City of Sebastopol Design Review Board Staff Report

Meeting Date: March 16, 2016
Agenda Item: 8B
To: Design Review Board
From: Jonathan Atkinson, Assistant Planner
Subject: Design Review: Second Unit
Recommendation: Approval with Conditions
Applicant/Owner: Caleb and Shannon Williams
File Number: 2016-05
Address: 7416 Calder Avenue
CEQA Status: Categorical Exemption: Section 15303: Class 3
General Plan: Medium Density Residential
Zoning: RSF-2: Medium Density Single Family Residential

**DESIGN REVIEW PERMIT: 2016
One-Story Second Dwelling Unit
7416 Calder Avenue**

SITE PLAN
 SCALE: 1" = 10'-0"

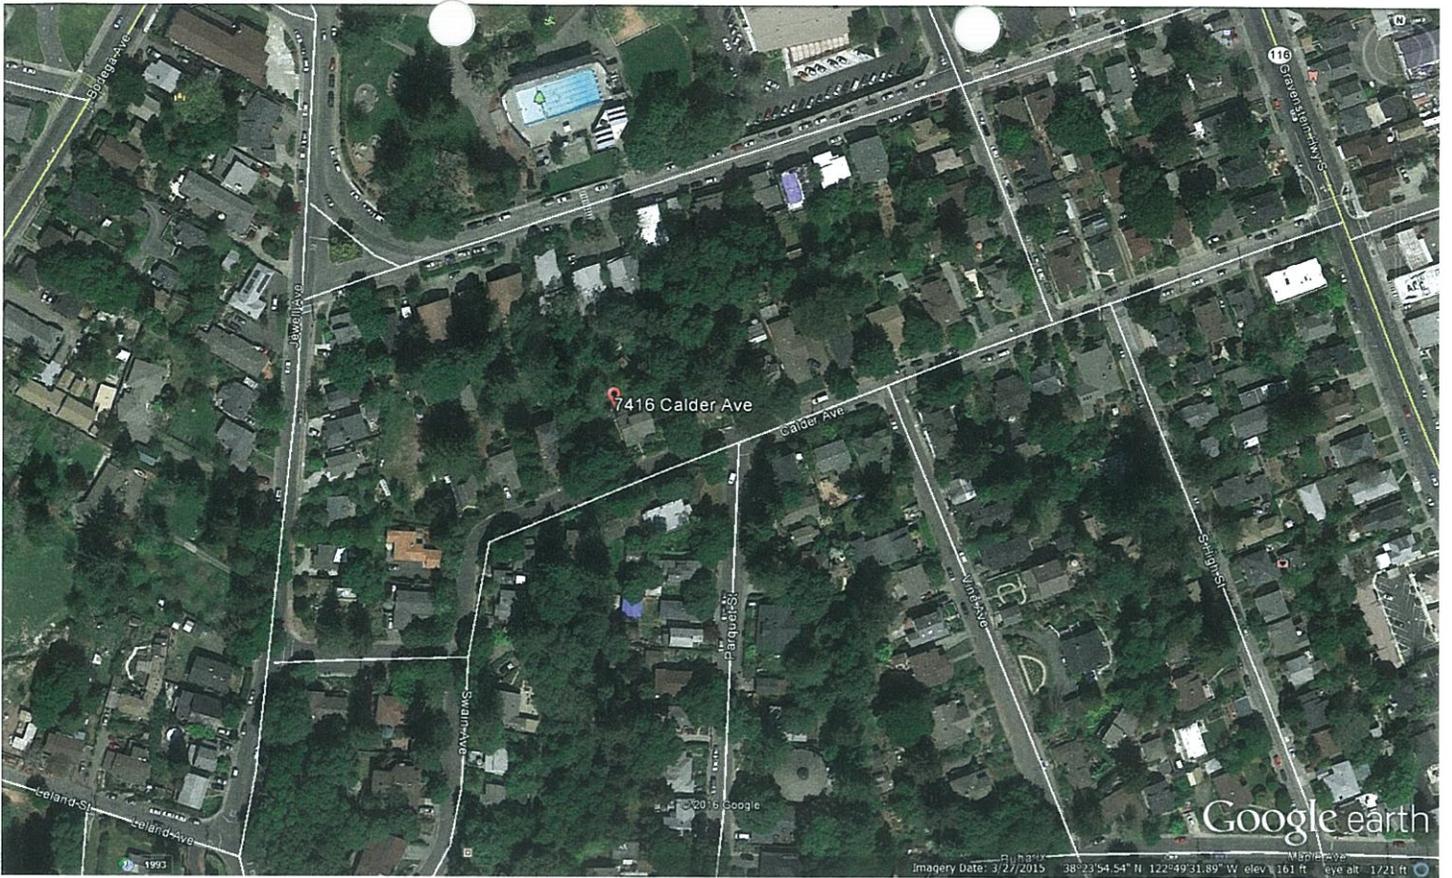
ADD TREE PROTECTION FENCING AS CLOSE TO PROPOSED DRIVEWAY AND STRUCTURE AS POSSIBLE.

ADD TREE PROTECTION FENCING AS CLOSE TO PROPOSED DRIVEWAY AND STRUCTURE AS POSSIBLE.

I have reviewed the Arborist's Report by David Fowler, dated February 2 for this project. We need specific Tree Protection Measures to accompany the Tree Location Map (marked up Site Plan) which designates which trees will have to be removed, and which are at risk during construction, and shows where replacement trees will be planted.

We need more specific information regarding the depth of, and construction details for the new sidewalk, driveway and granny unit foundation, and to know if roots of the 38" black oak (Tree A), and the 36" incense cedar (Tree B) will be impacted. The new driveway was recently graded – were any roots exposed or cut during that work? The property line tree's roots on the west side may be impacted by further driveway improvements.

One way to determine if roots will be found (and presumably cut) is to hand dig a trench at the limits of required work within the dripline of the cedar to the depth required for the driveway improvements and foundation within the dripline of the black oak and cedar. This work should be observed by the project arborist who should perform a site visit(s) during the trenching. If roots 2" and larger are found there should be recommendations from the arborist regarding alternative construction methods to preserve them. The architect/engineer should verify prior to that work that recommended means of preserving roots are acceptable.

The project arborist should also be present at somepoint during excavation for the foundation of the upper dwelling, where work will be done within the dripline of the large black oak, Tree A. The suggestion of a shallow depth, reinforced concrete sidewalk is excellent, if the City approves it. The arborist should oversee excavation for it was well, to determine if roots will be impacted.

Will there be a fence installed along the west property line? If not, there may be a need to plant narrow, upright evergreen screening shrubs along that planter area in lieu of additional trees, to provide privacy screening for both properties. A row of 15 gal. shrubs/trees along that property line may be needed. The Pacific wax myrtle proposed for replacement trees could serve this purpose unless the area is too narrow.

The site-specific Tree Protection Measures, to be reviewed and approved by the City Arborist may be required and provided as a condition of approval, prior to issuance of grading or building permits.

TREE A- TO REMAIN

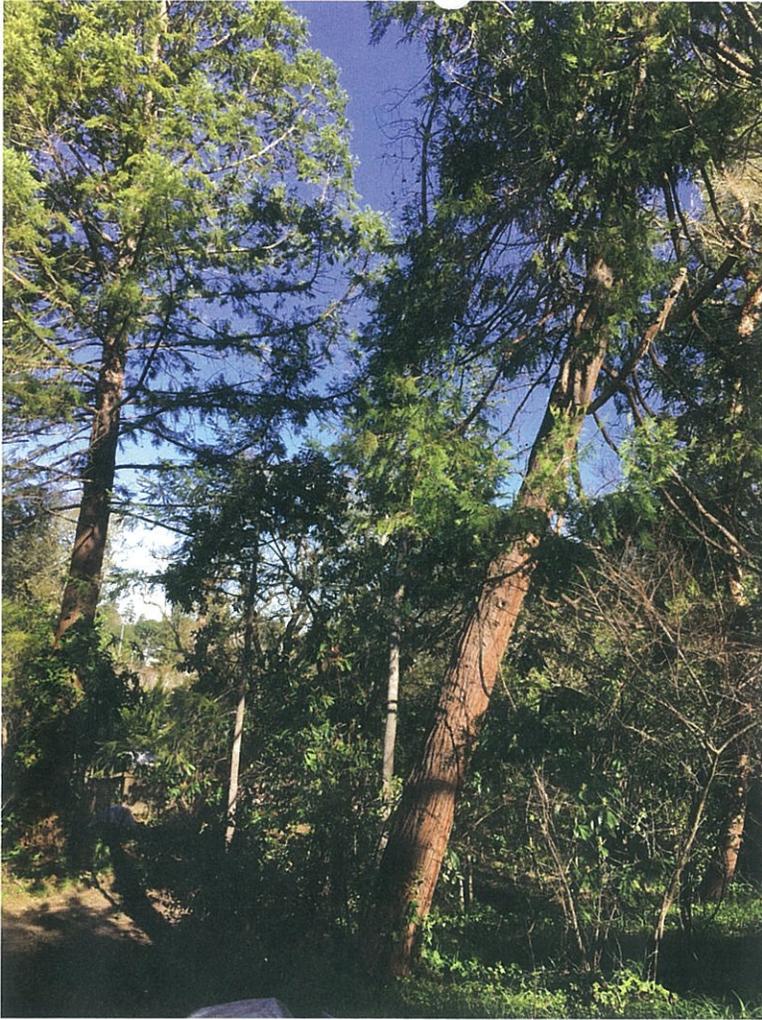
Tree "A" is a 38" DBH Black Oak (*Quercus kelloggii*) that appears to be in good health and has good to excellent structure. The tree sits near the street and proposed driveway. The basic grading for the driveway has already been completed and the construction of the residence below will have minimal impact upon this tree as long as tree protection fencing is put up around the dripline and construction equipment and materials are not stored around it. If a new side walk is to be put in along the street (it is currently unpaved), I recommend not over-excavating, and using reinforced concrete on grade to minimize root damage.

TREE B- TO REMAIN

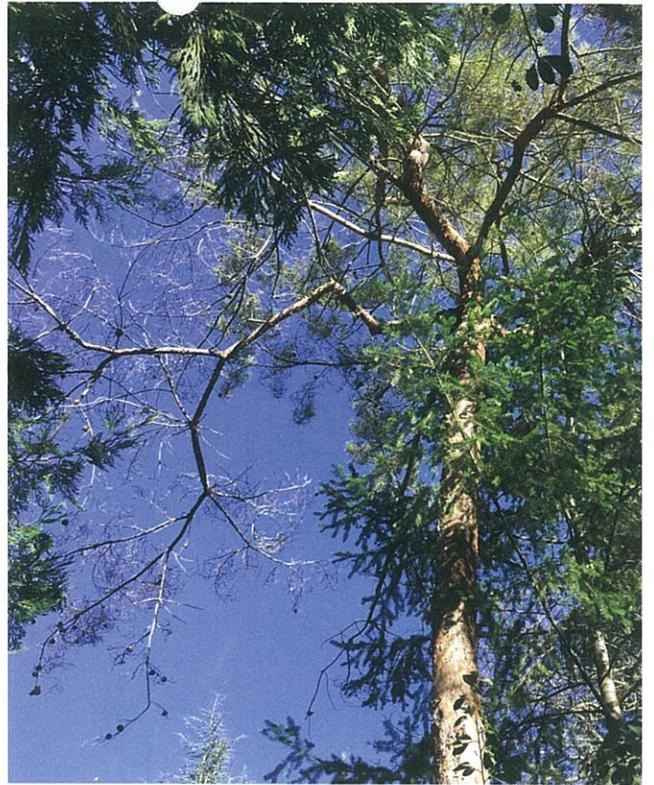
Tree "B" is a 36" DBH Incense Cedar (*Calocedrus decurrens*). It sits adjacent to the proposed driveway and granny unit. It appears in good health and has good structure. The driveway already exists, and as long as it is not further excavated, I do not think it will be further impacted by the driveway. However, tree protection fencing should be set up as close to the driveway and granny unit as possible to prevent root damage and compaction. Roots will likely be encountered when digging the foundation of the granny unit. This area should be hand dug (within reason) and roots should be cut cleanly with a saw.

TREE C- LEANING INCENSE CEDAR TO BE REMOVED

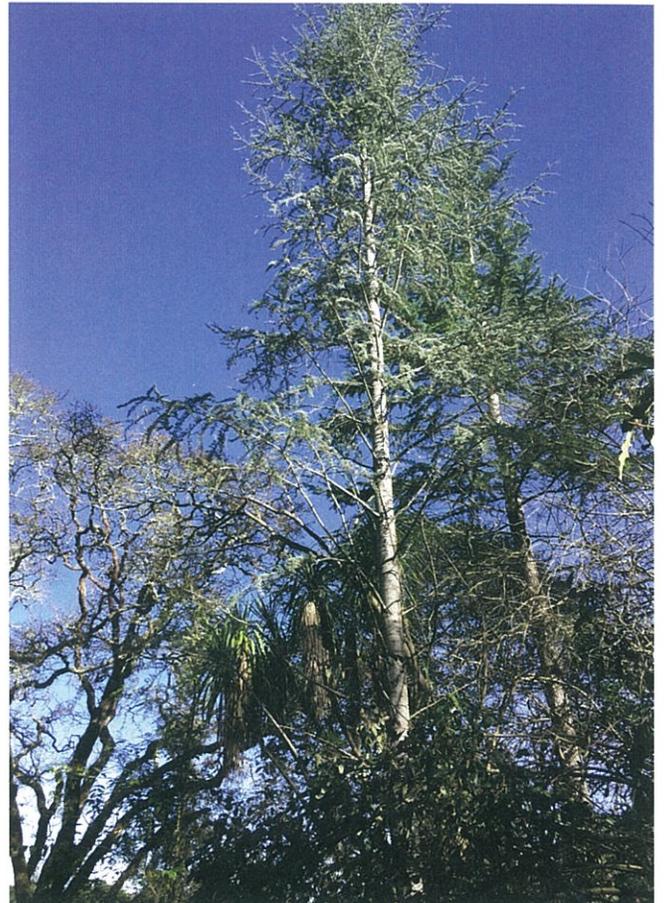
Tree "C" is a 21" DBH Incense Cedar (*Calocedrus decurrens*) that is not on the original site plan. It sits on the edge of the proposed residence, and will have to be removed. This tree appears to be in good health, but has fair structure because it has a significant lean for the first 15', then it straightens out. It is not an immediate hazard as it stands, but if a structure was placed adjacent to it, it would likely pose a hazard.

Tree "D" is a 12" DBH Pine sp (difficult to ascertain exact species at time of site visit). This tree appears to be in good health, but has poor structure. It was topped at some point and now has multiple leaders with weak attachment points. It sits where the proposed residence is located and will have to be removed.

TREE E- DEODAR CEDAR TO BE REMOVED

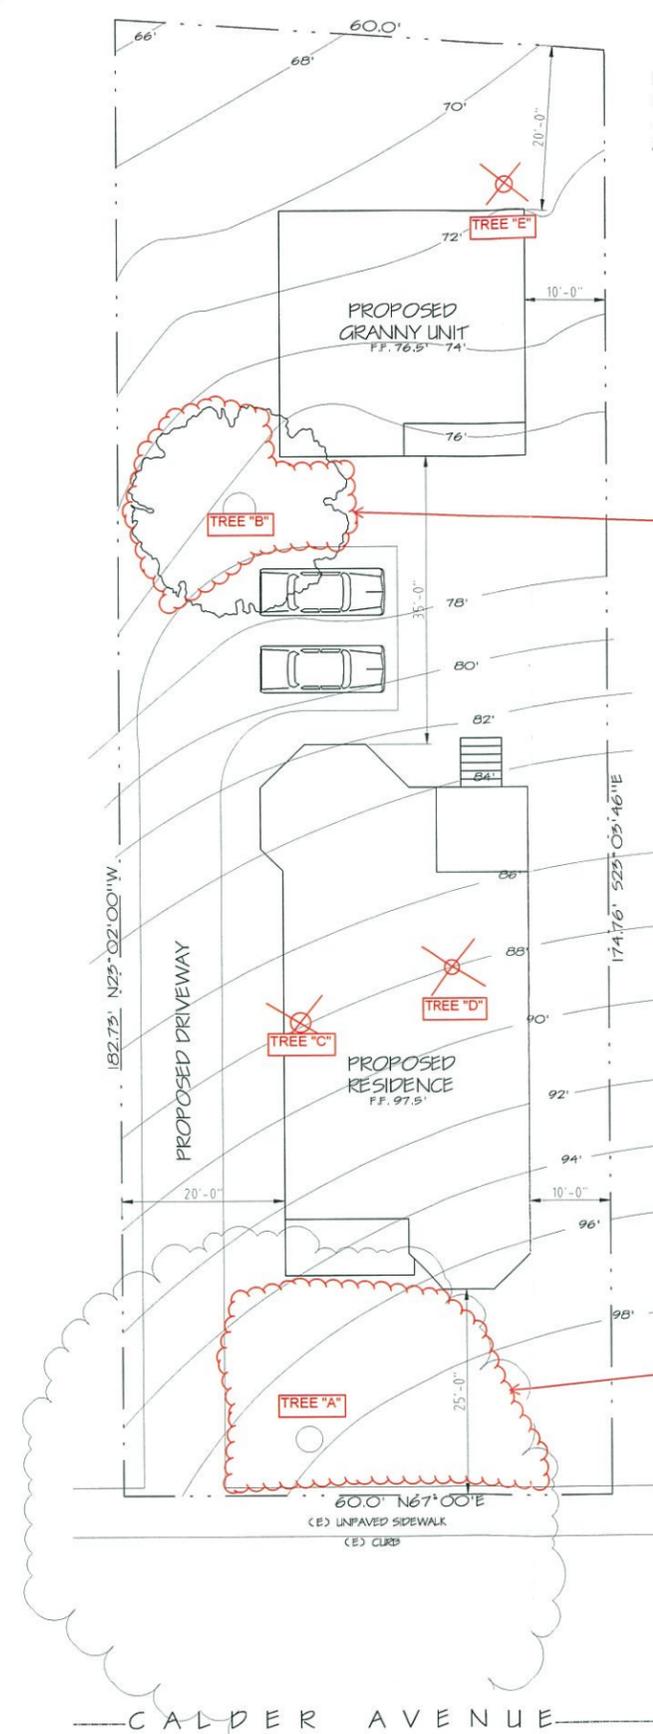
Tree "E" is an 11" DBH Deodar Cedar (*Cedrus deodara*). This tree is located at the corner of the proposed granny unit, and will also have to be removed for construction. This tree is in good health and has good structure.
